**WILLOWS UNIFIED SCHOOL DISTRICT**  
**Office of the Superintendent**

**AGENDA TOPIC:    Ginno Construction General Contractor – Willows High School Front Office Modernization Project – Change Order No. 01 for Additional Abatement**

**CHANGE ORDER NO. 01**

Subject: Willows High School Front Office Modernization  
 Willows Unified School District  
 Architect's Project No.: 3592003000

PROPOSED CHANGE ORDER: 7

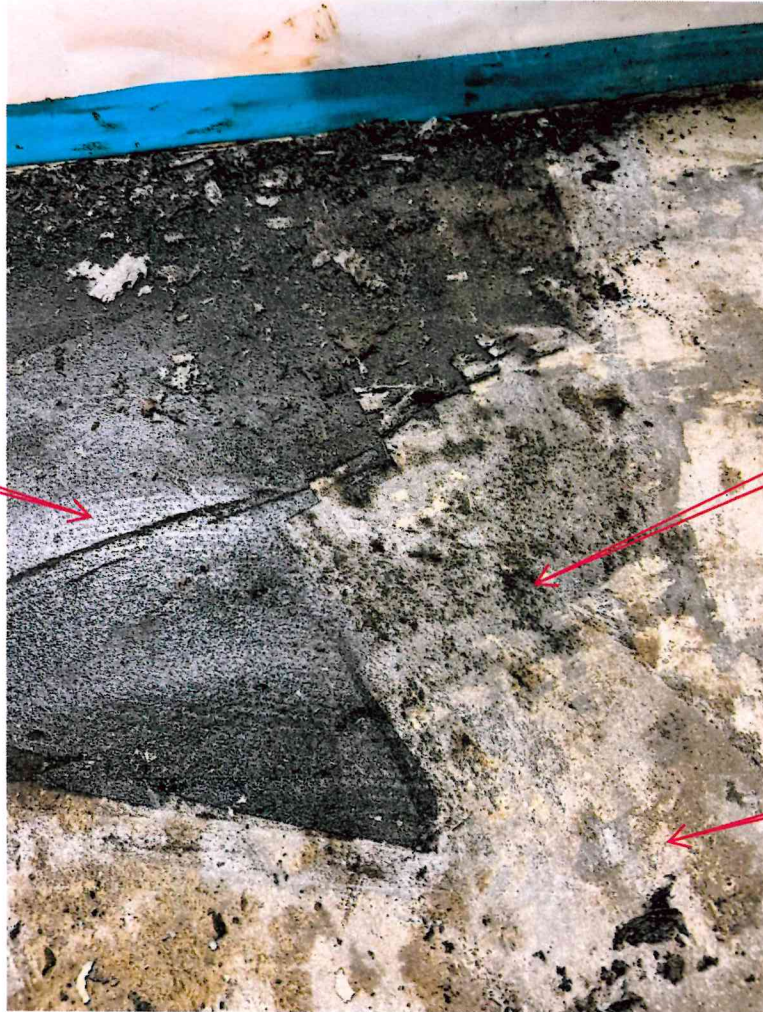
AFM Environmental - Additional Abatement - flooring	\$12,804.00
Throughout the office area (not the lobby), there are 2 layers of mastic needing to be abated. The section we are dealing with is VCT tile over mastic, over self-leveling compound, over mastic, which is over the foundation. (see attached photo for verification)	
	\$12,804.00
Contractor Markup (5%)	\$640.20
Total	<u>\$13,444.20</u>

This is the second layer of mastic that had to be removed below white underlayment

This is what remains of the first layer of mastic removed.

This white material is the underlayment found throughout offices

This is the typical condition found throughout the offices. This condition was not in the lobby.

**Cost is acceptable to district**
